**CITY OF ST. HELENS PLANNING DEPARTMENT  
STAFF REPORT  
Conditional Use Permit CUP.5.23**

**DATE:** November 7, 2023  
**TO:** Planning Commission  
**FROM:** Jennifer Dimsho, AICP, Associate Planner  
Jacob A. Graichen, AICP, City Planner

**ZONING:** Light Industrial (LI)  
**LOCATION:** 4N1W-8AD-1401; Vacant lot southeast of 35835 Industrial Way  
**PROPOSAL:** Conditional Use Permit to construct office use on Parcel 2 of PP 2008-17. Office use is conditionally allowed with the property classified as an “industrial park” along with Parcel 1 and 3 of PP 2008-17. See Permitting History for more detail.

SHEET  
**C-5**

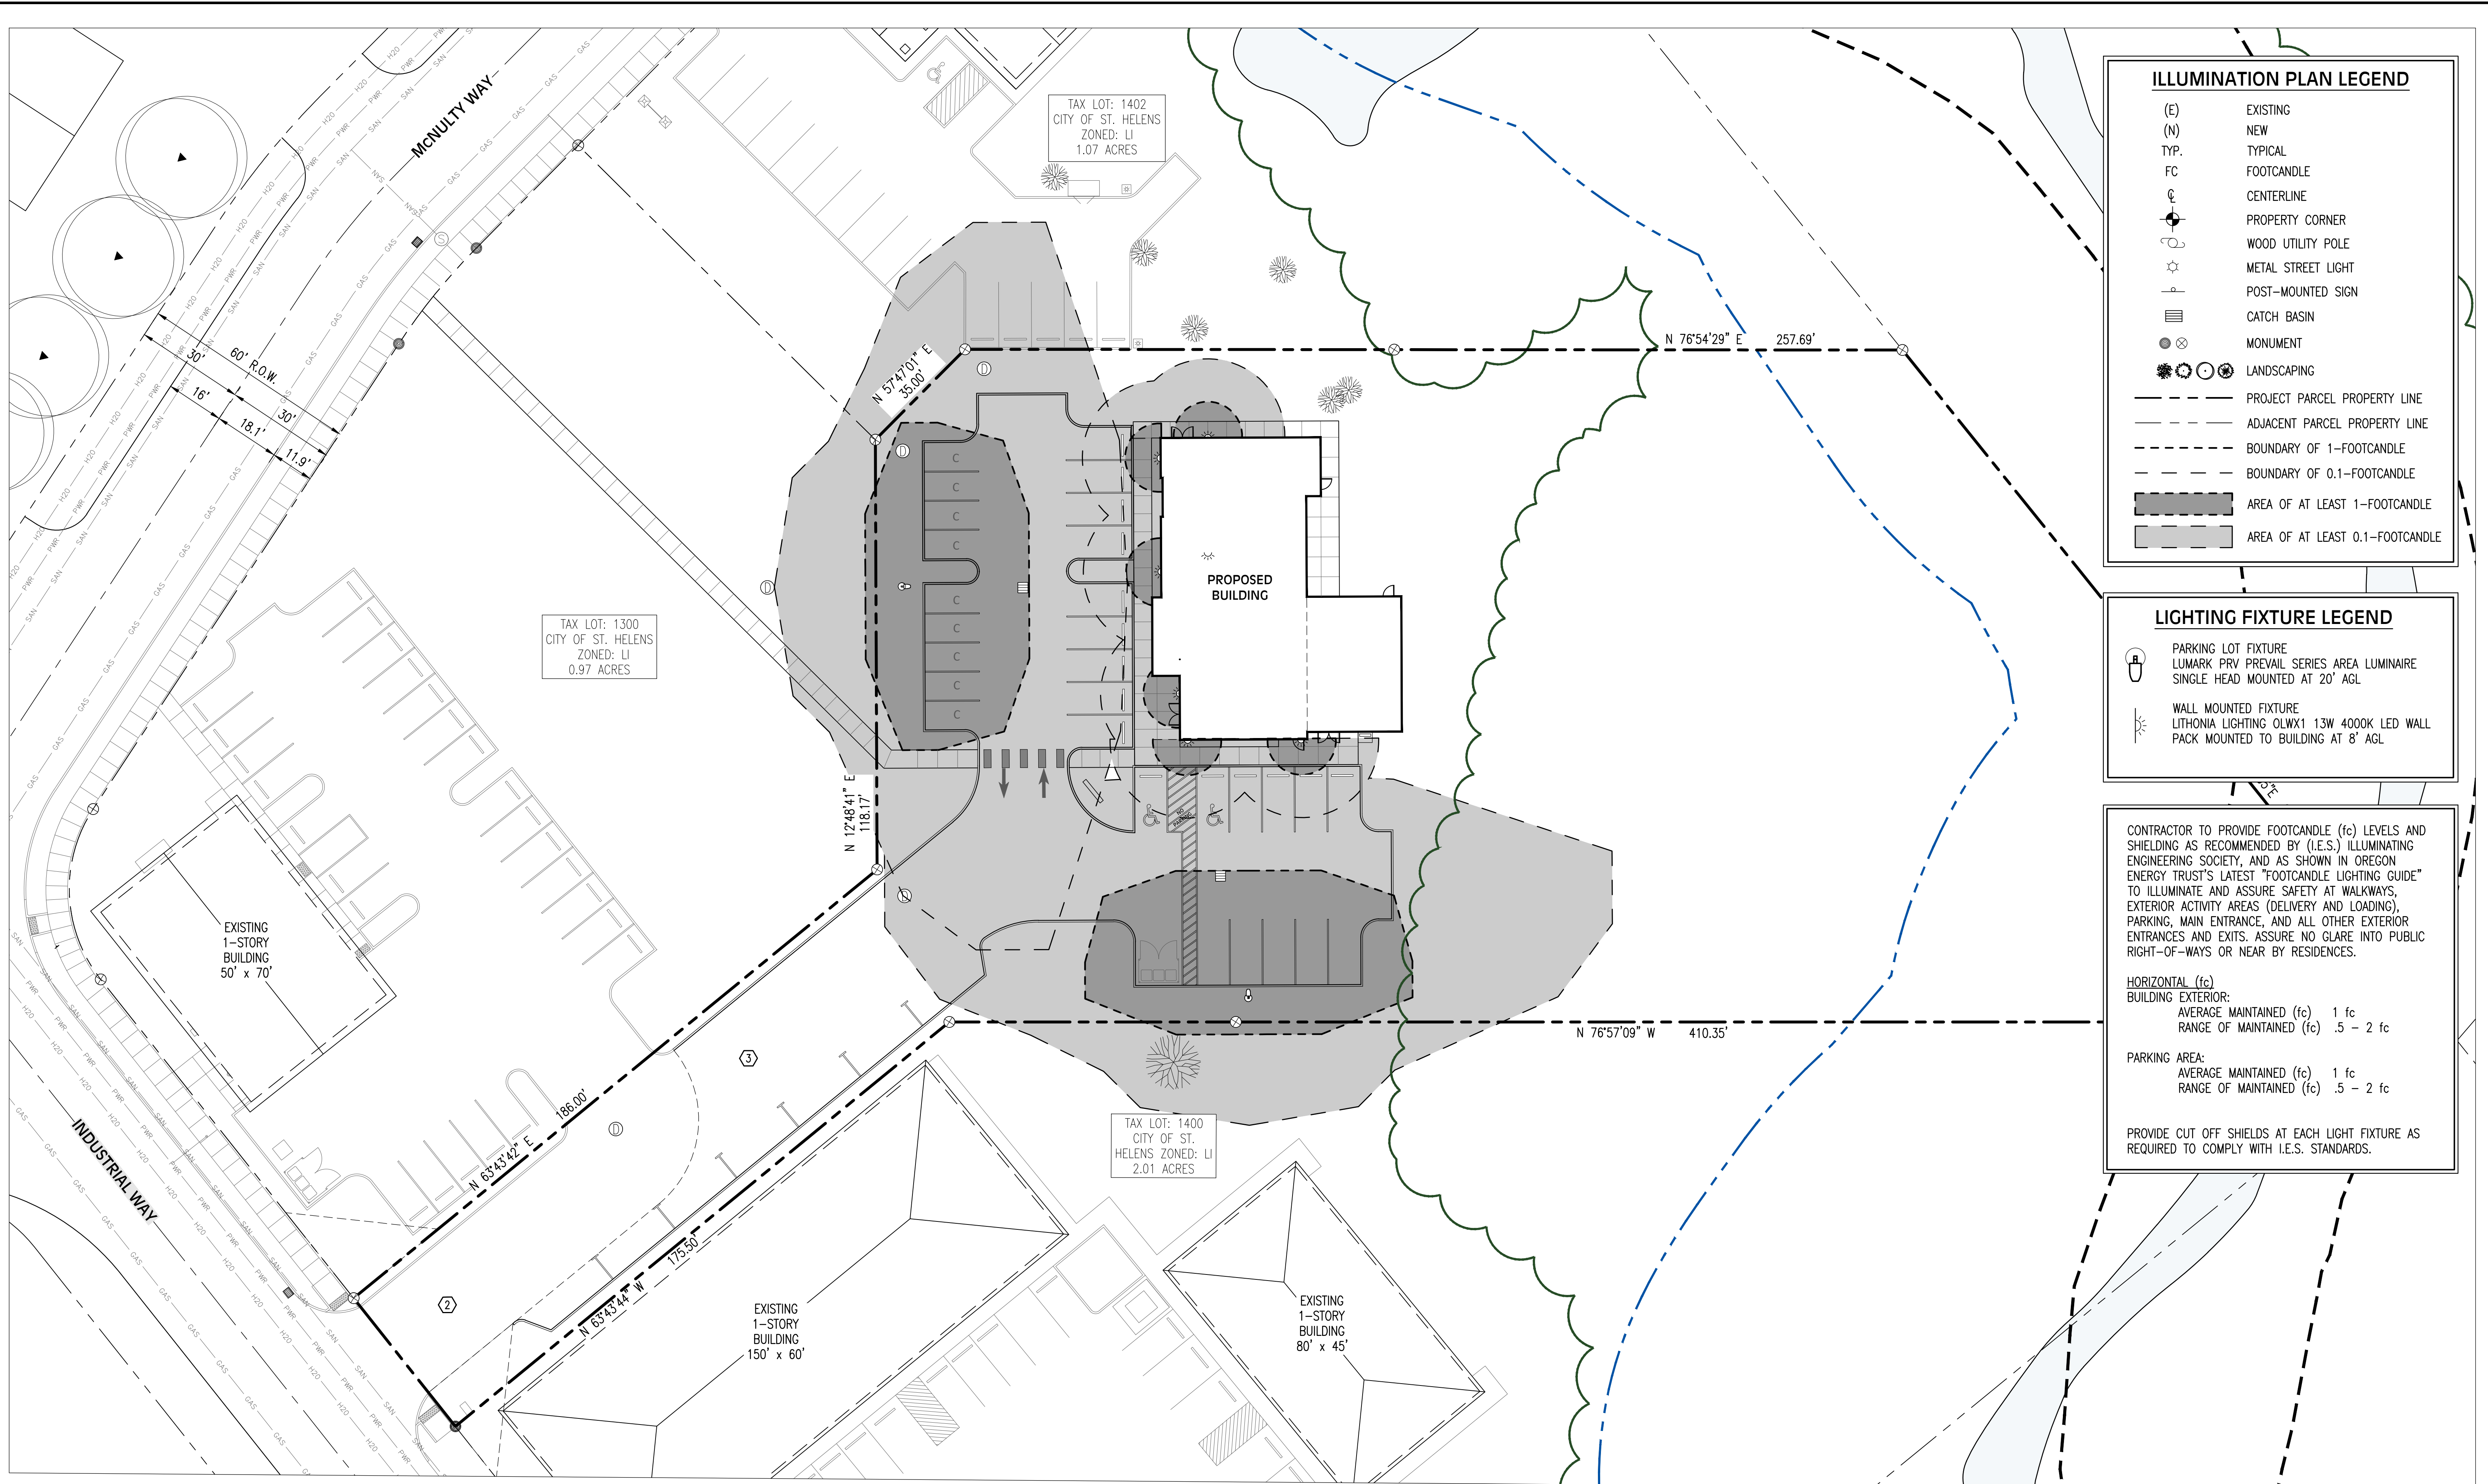
**Interior parking lot landscaping.** When off-street parking lots have more than 20 spaces, landscape islands are required with trees. Rows of parking spaces are not to exceed 7 spaces, generally. The "islands" are required to be no less than 48 sq. ft. in area and no dimension less than six ft. They are required to have a combination of groundcover and shrubs in addition to a tree, such that at least 50% of the island will be covered with living plants. They are also required to be protected from vehicular damage by some form of wheel guard or curb that is permanently fixed to the ground. There are two required landscape islands shown. Plans reflect them at 6' wide without curbs, and they are at least 87 sq. ft. They show groundcover and one tree in each. They also have curbs surrounding them.

**Dimension and type.** There is a mix of standard spaces (min. size 9' x 18') and compact spaces (min. size 8' x 15') shown on the plans. All compact spaces are required to be signed or labeled by painting on the parking space. There are also 7 parallel spaces shown at 8' x 22'.

**Bicycle parking.** 1 lockable space is required at a rate of 10% of vehicle spaces. The applicant states that they are providing a total of 4 bicycle spaces, but only 2 spaces are proposed, and the area provided is deficient for the standard size bicycles. **The Commission must decide if the applicant should provide 10% of the minimum required parking spaces (10% of 24) which would be 2 spaces, or 10% of the parking spaces they are providing (10% of 36) which would be 4 spaces.** In addition, bicycle spaces are required to be within 50' of primary entrances, under cover when possible, and not located in parking aisles, landscape areas, or pedestrian ways. If only 2 spaces are required, typically, we do not require covered bicycle parking because it is too small to warrant it. **Since this is a CUP, the Commission should weigh in on whether the bicycle parking should be covered.**

To meet this requirement, the applicant is proposing a walkway through property addressed 35835 Industrial Way. This will need to be formalized with a shared pedestrian access easement. There is also an entry door on the north façade of the building which does not have a required walkway. This will need to be addressed with the revised plans.

**Fire access.** Access drives in excess of 150' in length must provide an approved fire turnaround as approved by the fire marshal. This appears to be met with a "Y-shaped" turn around which is within the parking lot drive aisles. The proper radius is not shown and must be reflected on a revised plan. Any requirements of the Fire Marshall shall be met.

SHEET  
**C-6**

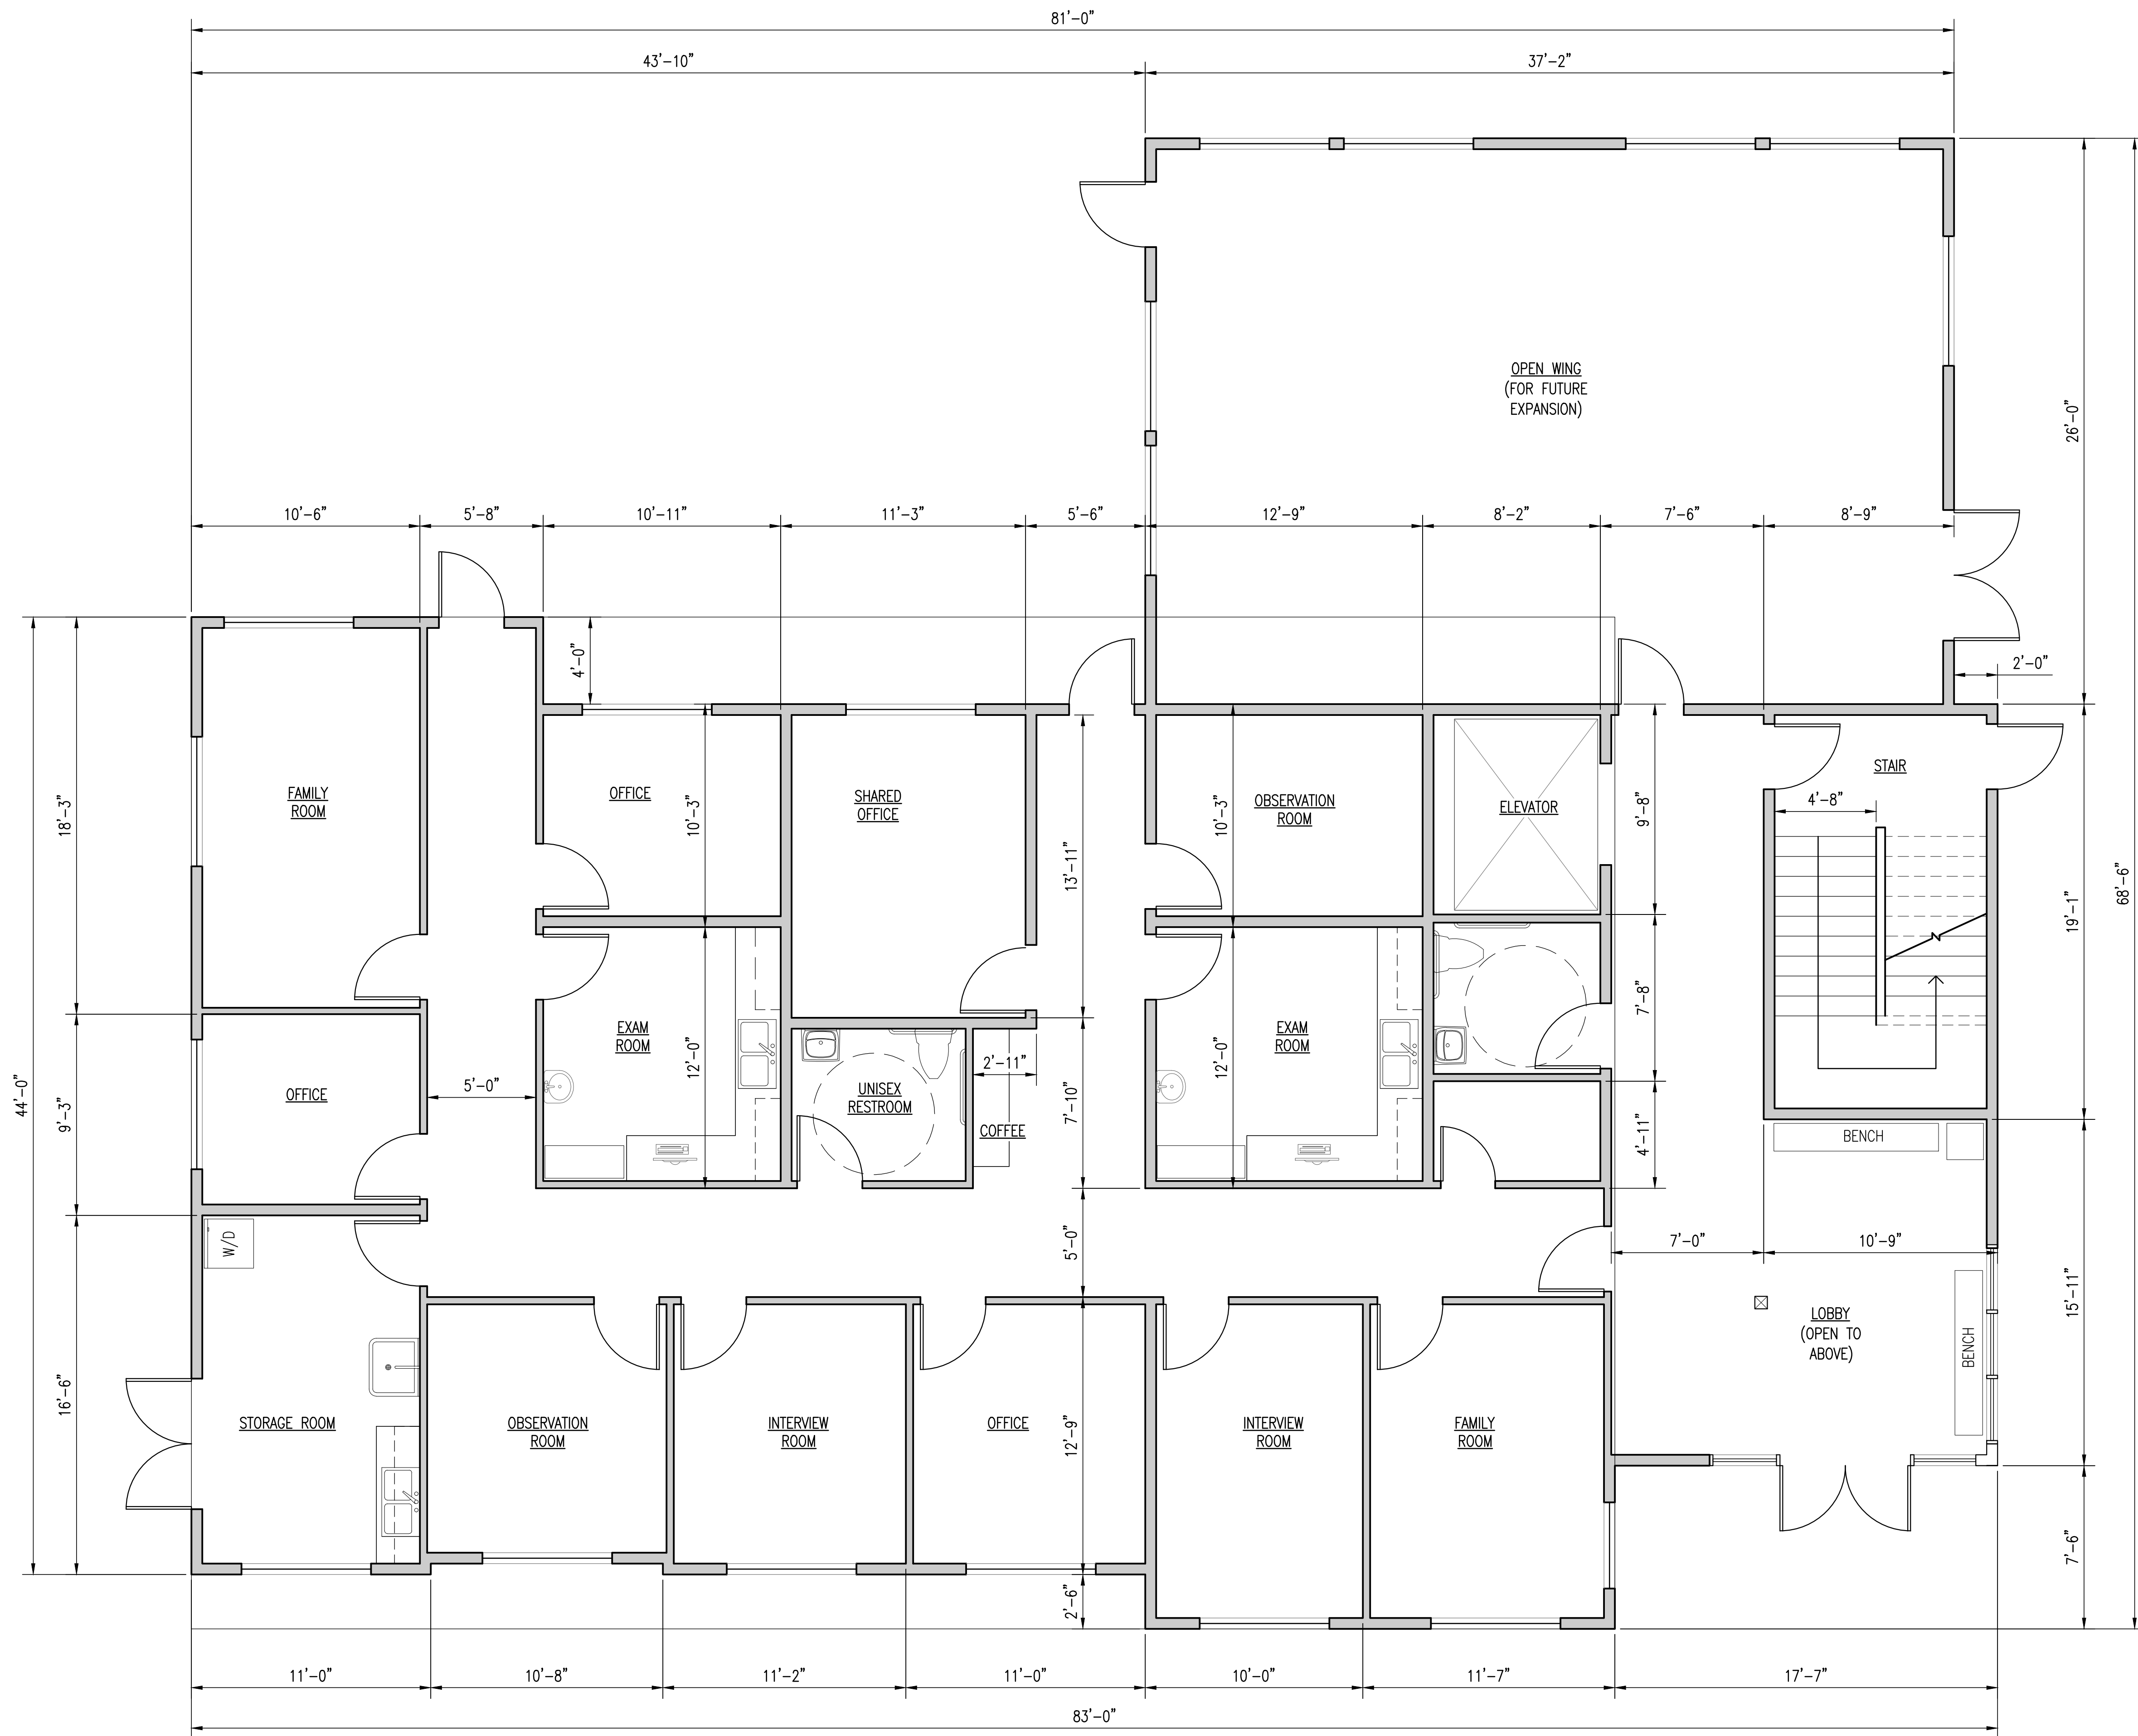
Required walkways shall be paved with hard-surfaced materials such as concrete, asphalt, stone, brick, etc. Walkways shall be required to be lighted and/or signed as needed for safety purposes. All walkways are shown as being paved and the lighting plan shows must being illuminated. However, the proposed walkway to McNulty Way and the walkway behind the building are missing illumination. This must be shown on a revised illumination plan.

**Crime prevention.** Light fixtures shall be provided in areas with heavy pedestrian or vehicular traffic and in areas potentially dangerous such as parking lots, stairs, ramps, and abrupt grade changes. Fixtures shall be placed at a height so that light patterns overlap at a height of 7'. An illumination plan was provided that shows a combination of six (6) wall mounted lights on the building and two (2) pole mounted lights in the parking lot. It shows sufficient illumination of the site. However, the west pole mounted light must be relocated out of the public utility easement to avoid utility conflicts. Illumination of all walkways (behind the building and to McNulty Way) is also required.
